Intel Technical Advisory

TA-1165

Incorrect Cabling on LWF2224NX Leads to Erroneous Display in Nutanix* PRISM Hardware Diagram

Figure 1. Cable routing for LWF2224NX servers. Green cables/drives represent NVMe drives for SATA+NVMe configurations.

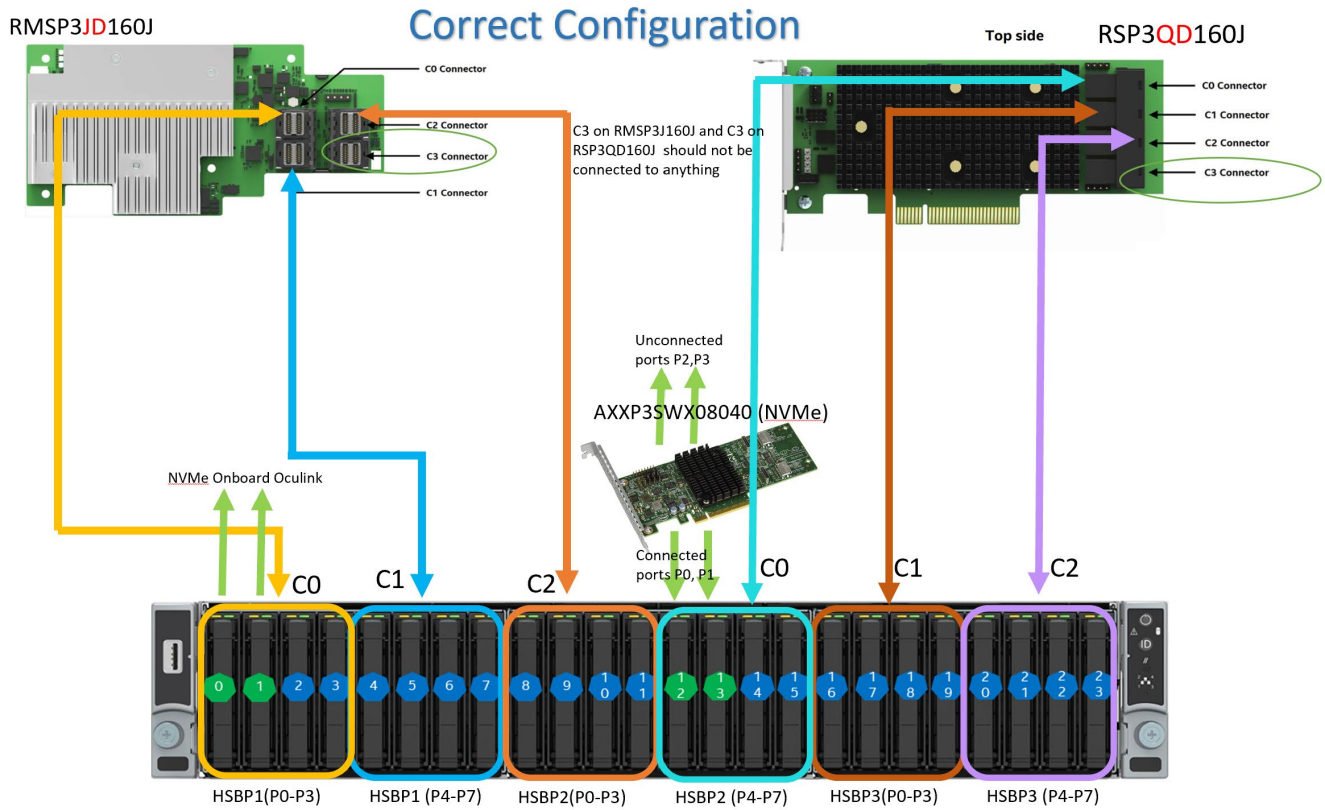
This was first reported by an Intel customer and the root cause and corrective steps to remediate the problem was determined internally at Intel. Factory instructions for port map cable connections for C0-C1 in RSP3QD160J were incorrect. These have been corrected and addressed, so that factory instructions now contain the correct cabling instructions.

The resolution is to swap the C0-C1 cabling for RSP3QD160J: card port C0 should connect to drive slots 12–15, and card port C1 should connect to drive slots 16–19. Incorrect cabling will have C1 connected to 12–15, C0 connected to drives 16–19. Once these are cabled according to Figure 1, Nutanix* PRISM hardware diagram will no longer have erroneous display and will report correct drive identifier in case of drive failure.

| Use configured AXXCBL800HDHD cable to connect from Controller card connector C0 to the drive bay 2 SAS/SATA ports 4–7 (route left) |
| Use configured AXXCBL875HDHD cable to connect from Controller card connector C1 to the drive bay 3 SAS/SATA ports 0–3 (route right) |
| Use configured AXXCBL950HDHD cable to connect from Controller card connector C2 to the drive bay 3 SAS/SATA ports 4–7 (route right) |
